**ANSTY GARDEN COMMUNITY,**

**DESIGNERS RESPONSE**

**REPORT REF NO. 2207280-R13**

**Road Safety Audit Stage 1**

Drawing Title: PROPOSED ROUNDABOUT NORTHERN ACCESS (A272)

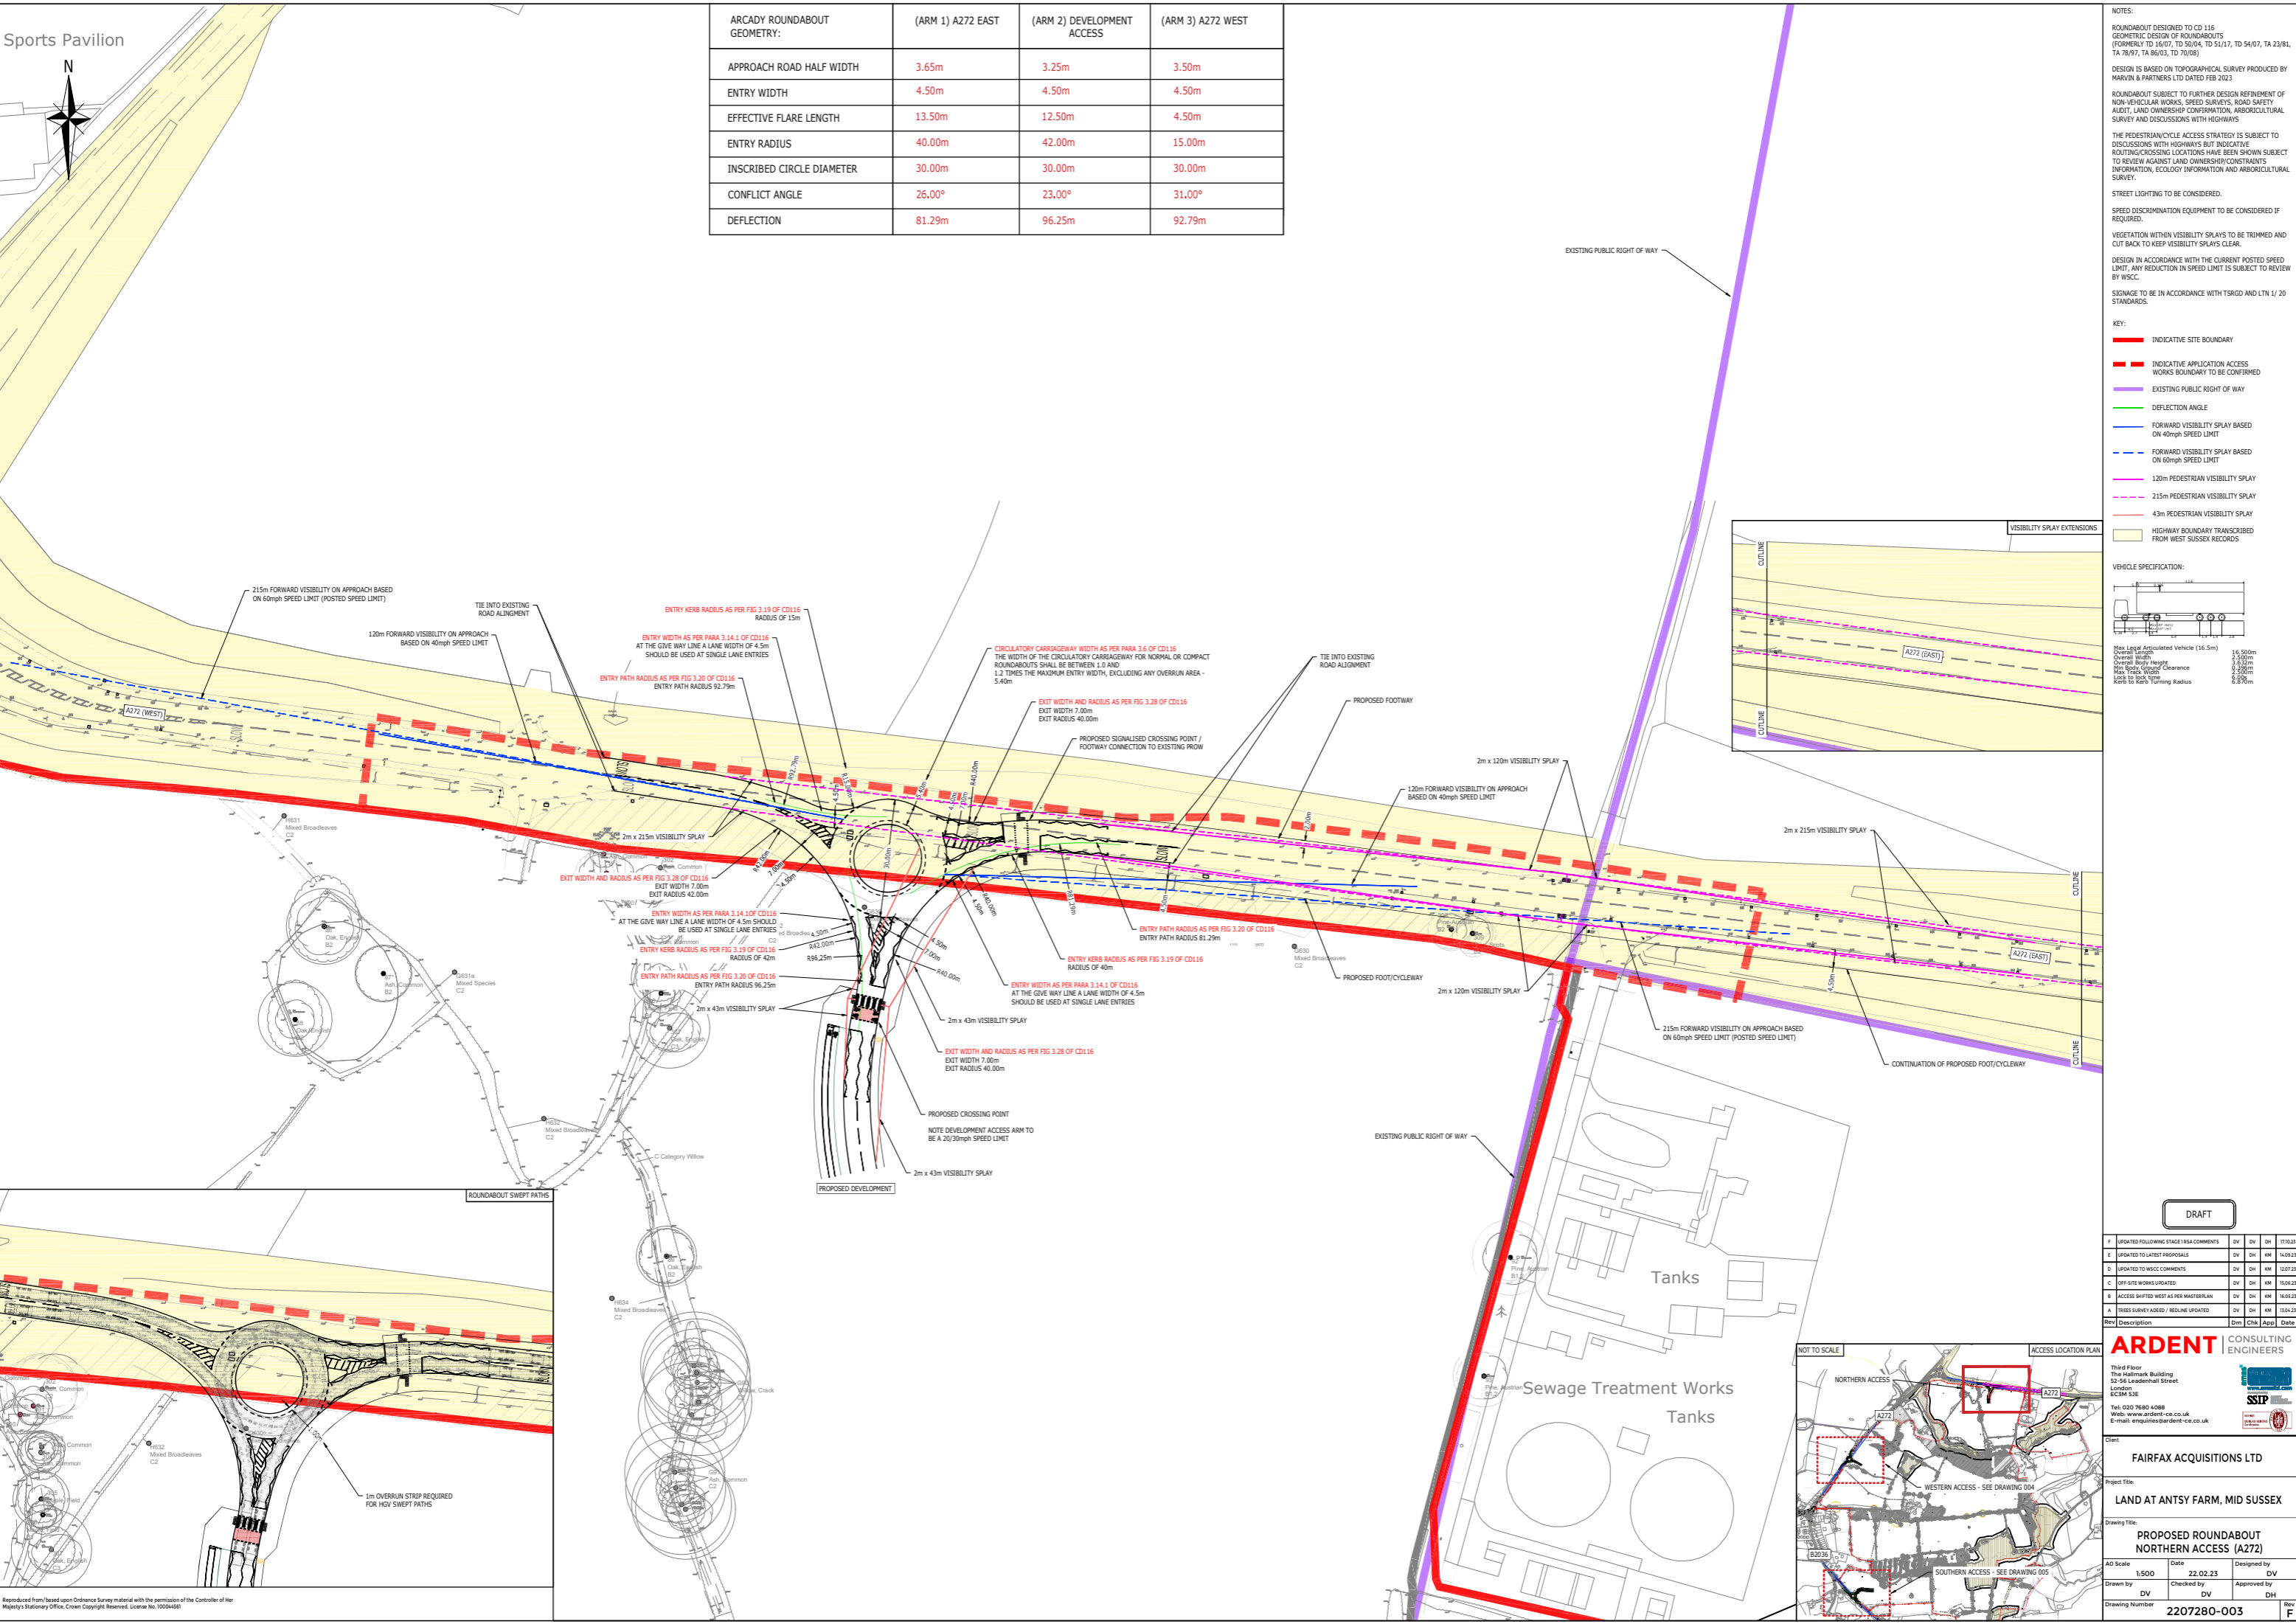
<p>3.1.5 Inappropriate vehicle speeds could lead to could lead to vehicle to pedestrian / cyclist collisions or rear end shunts.</p> <p>A national speed limit currently applies to this</p>	<p>It is recommended that a 30mph speed restriction should be applied to the southern arm of the roundabout.</p>	<p>Agree, the southern arm (development access arm) will be subject to a 20/30mph speed limit as noted on <b>ACE Drawing 2207280-003F</b>.</p> <p>Signage to be in accordance with TSRGD and LTN1/20</p>

<p>3.2.2 Insufficient Stopping Sight Distance may increase the risk of junction related or shunt type collisions at the roundabout.</p> <p>On the westbound approach to the roundabout there is concern that the SSD could pass over non-highway land. Vegetation or landscaping features in this splay could restrict visibility, where insufficient visibility may increase the risk of junction related or shunt type collisions at the roundabout.</p>	<p>It is recommended that the SSD should be supplied for assessment and that they should be within the adoptable highway, or that a suitable covenant should be arranged to ensure that the splay is not affected by planting or landscaping features.</p>	<p>All visibility splays are within highway land or land within the development site and therefore can be kept clear as shown on <b>ACE Drawing 2207280-003F</b>.</p>

<p>3.2.3 Insufficient Stopping Sight Distance may increase the risk of vehicle to pedestrian / cyclist collisions or rear end shunts.</p> <p>On the approaches to the Parallel crossing no SSD has been provided for assessment. There is concern that the SSD could pass over non-highway land. Vegetation or landscaping features in this splay could restrict visibility, where insufficient visibility may increase the risk of vehicle to pedestrian / cyclist collisions or rear end shunts.</p>	<p>It is recommended that the SSD should be supplied for assessment and that they should be within the adoptable highway, or that a suitable covenant should be arranged to ensure that the splay is not affected by planting or landscaping features.</p>	<p>The proposed parallel crossing is located on the development access arm and will be subject to a 20/30mph speed limit subject to public transport requirements. 2m x 43m visibility splays have been shown on <b>ACE Drawing 2207280-003F</b>.</p>

DESIGN IN ACCORDANCE WITH THE CURRENT POSTED SPEED  
 LIMIT, ANY REDUCTION IN SPEED LIMIT IS SUBJECT TO REVIEW  
 BY WSCC.  
 SIGNAGE TO BE IN ACCORDANCE WITH TSRGD AND LTN 1/20  
 STANDARDS.

Rev	Description	Dm	Chk	App	Date
F	UPDATED FOLLOWING STAGE 1 RSA COMMENTS	DV	DH	DM	17.02.21
E	UPDATED TO LATEST PROPOSALS	DV	DH	DM	14.09.21
D	UPDATED TO WSCC COMMENTS	DV	DH	DM	12.07.21
C	OFF-SITE WORKS UPDATED	DV	DH	DM	18.06.21
B	ACCESS SHIFTED WEST AS PER MASTERPLAN	DV	DH	DM	18.05.21
A	TREES SURVEY ABEID / REDLINE UPDATED	DV	DH	DM	13.04.21
